# Access Compliance Report

## Public Rights-of-Way

Intersection ID: 10041624	Main Street: WHITEHALL EXECUTIVE CENTER DR	Cross Street: N/A	Location: NE
ADA ID: 5A5D0BAC550A	Ramp Type: Perp	Initial Pass/Fail: Pass	Overall Compliance: No
Severity Score: 0			
Codes/Mitigation Info/Possible Solution		Field Measurements/Component Compliance

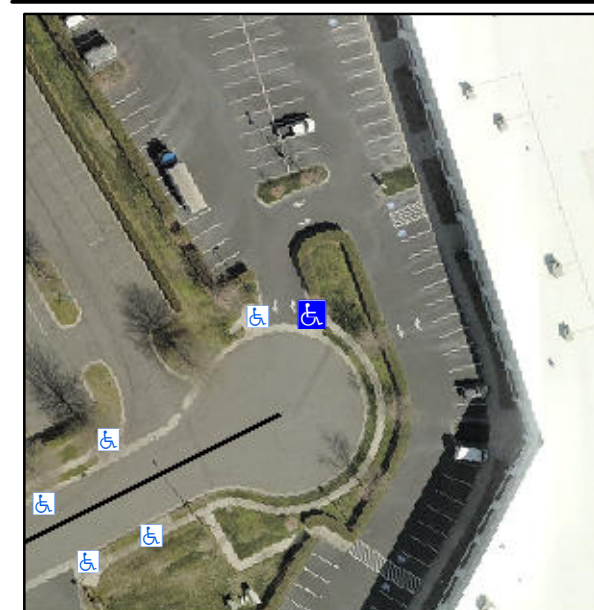
**Remove & Replace Landing.  
Remove & Replace Gutter.**

**R304.2.2-Perp, R304.3.2-Para,  
R304.5.3**
